# SERVICE No. 773A BULLETIN

(Service Bulletin No. 773A supersedes and voids Service Bulletin No. 773, dated December 19, 1983.)

Bulkhead (Fuselage Station 332.0)  
Inspection

PA-31T Cheyenne/Cheyenne II  
PA-31T1 Cheyenne I/IA

REAR VIEW OF BULKHEAD LOOKING FORWARD

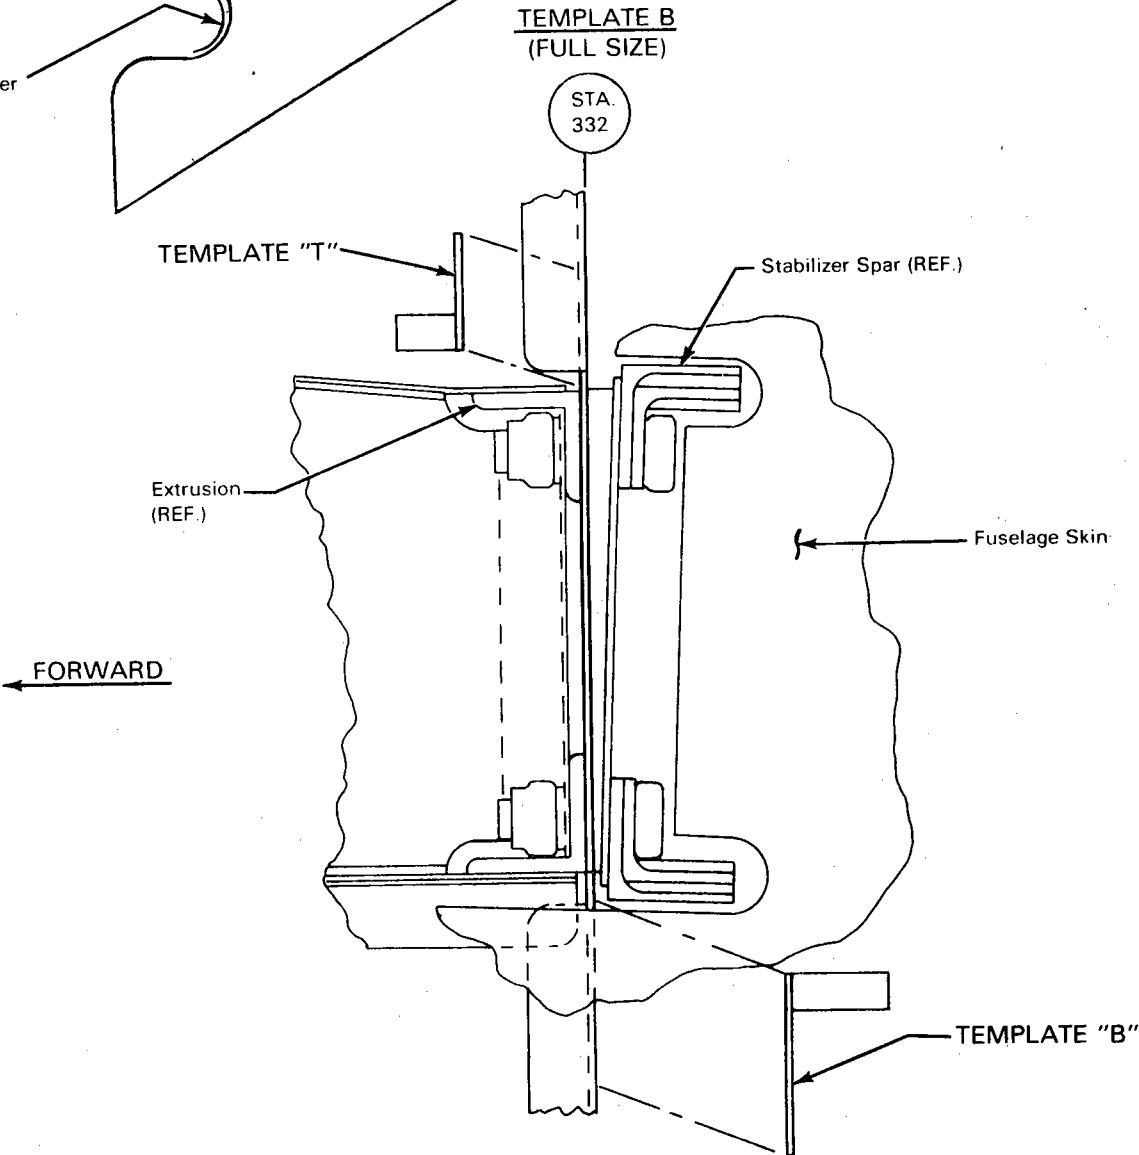
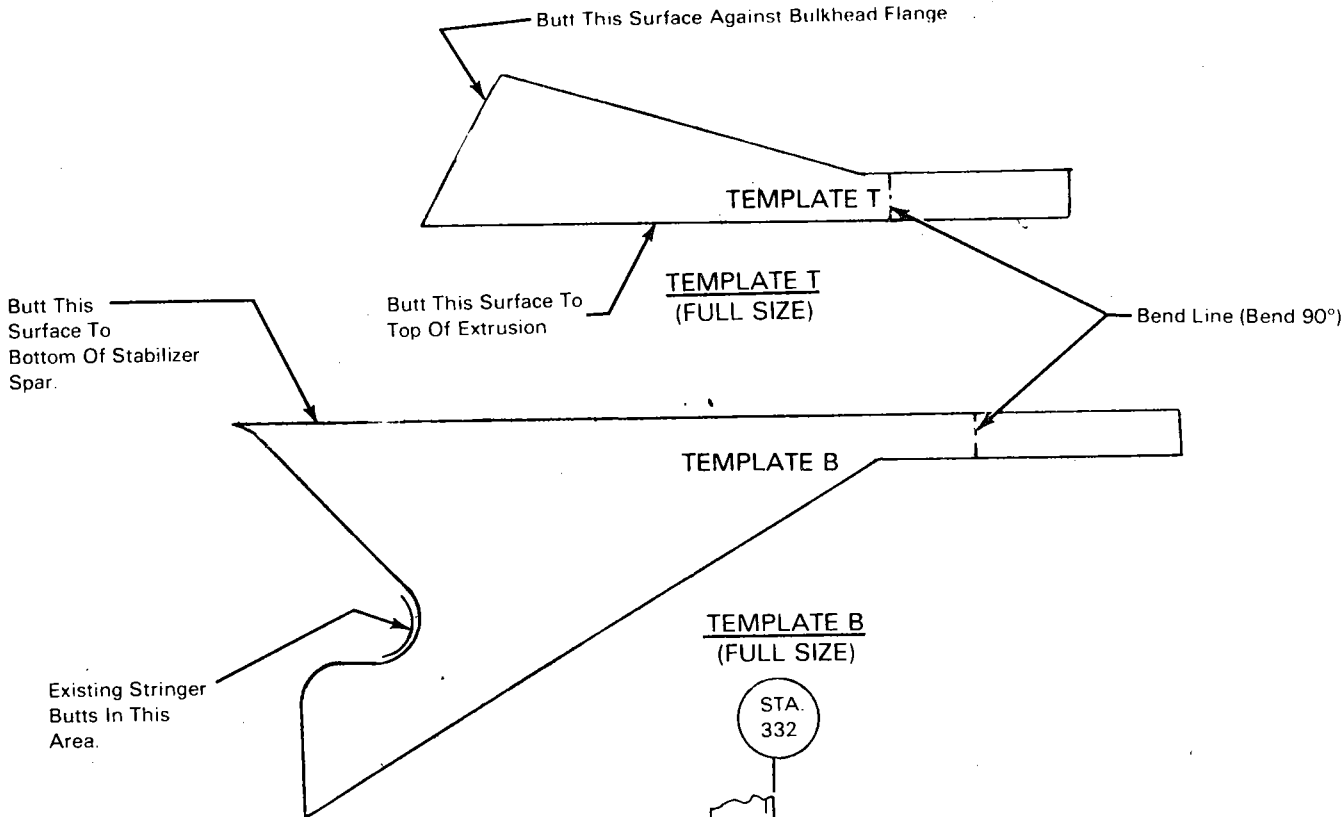
1. Gain access to the bulkhead area shown in Sketch A by removing the wrap-around fairings from the horizontal stabilizer to the fuselage and the access plates in the Station 332.0 area.
2. Using Dye Penetrant Inspection method, inspect the Fuselage Station 332.0 bulkhead for cracks in the areas shown in Sketch A.
  - a. If no cracks are found to exist proceed to Instruction 3 below. A repetitive inspection is required at each 200 hours of operation.
  - b. If cracks are found, and cracks do not exceed the following limitations, cracks must be stop drilled and Reinforcement Kit 764 983 must be installed before further flight.

LIMITATIONS: Cracks which originate at the relief notches or stringer cut-outs (See Sketch A) which do not exceed 1.5 inches in length and which do not extend above the top edge of Template "T" or below the bottom of Template "B" may be repaired per Instruction 2.b.

Bulkheads With Cracks In Areas Denoted By Shading (See Limitations) May Be Repaired Per Instruction 2b.

- c. If cracks are found to exceed the specified limitations, replace bulkhead assembly with Reinforced Bulkhead Assembly Part No. 45583-16 or 45583-17 before further flight.
3. Reinstall fairings and make appropriate logbook entry of compliance.
